## PUBLIC HEARING MEMORANDUM

SUBJECT: **Petition #219-21** for SPECIAL PERMIT/SITE PLAN APPROVAL to allow a drive-in establishment, to waive perimeter screening requirements and to waive outdoor lighting requirements at 940 Boylston Street, Ward 5, Newton Highlands, on land known as Section 51 Block 26 Lot 03, containing approximately 12,060 sq. ft. of land in a district zoned BUSINESS USE 2. Ref: Sec. 7.3.3, 7.4, 4.4.1, 6.4.11, 5.1.9.A, 5.1.13, 5.10.A of the City of Newton Rev Zoning Ord, 2017.

**940 Boylston Street**

**Re: 940 Boylston Street (Dunkin') Traffic Impact Analysis Peer Review**

Proposed Site Plan

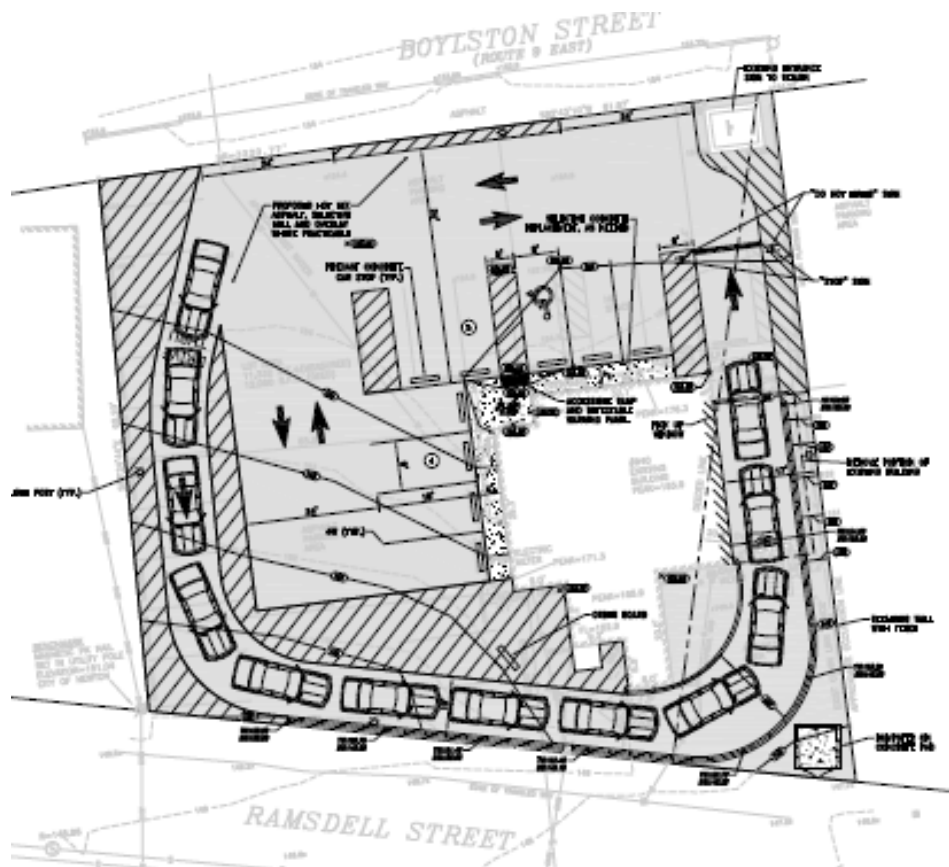
The petitioner proposes to raze 415 square feet of the structure on the eastern elevation to accommodate a “drive through window”. An order board would be located at the southern portion of the site, along Ramsdell Street. The demolition of the eastern portion of the building increases the side setback to seventeen feet, where three feet exists.

The petitioner is also proposing to construct a retaining wall along the southern and eastern property lines. The wall reaches a maximum height of 4.75 feet at the southeast corner. The petitioner should confirm whether this wall is located within the setback distance

Additionally, BETA questioned why the drive-thru lane is 10-feet wide when 12 feet is the minimum in the zoning ordinance, why the parking stalls are 18-feet long in lieu of the 19-foot zoning requirement, where and when loading and deliveries will occur on site, and how potential queues onto Route 9 would be mitigated.

Outdoor parking facilities containing more than five stalls are required to provide perimeter screening from abutting streets and properties. The petitioner has not submitted a landscape plan showing any screening, thus is seeking a waiver from the perimeter screening requirement. Though they have requested a waiver, the petitioner should submit a landscape plan with any proposed screening.

The lighting plan indicates that portions of the parking area would not meet the requirement per Sec. 5.1.10.A's that outdoor parking facilities used at night provide lighting with a minimum intensity of one-foot candle on the entire surface. However, there are only a few sections of the site that would not meet the one-foot candle requirement which is limited to the northwest and southeast corners of the site with illumination levels between 0.5-0.9. The interior of the site reaches illumination levels between 1.0-4.0. The petitioner is seeking relief from the one-foot candle lighting requirements for outdoor parking facilities.
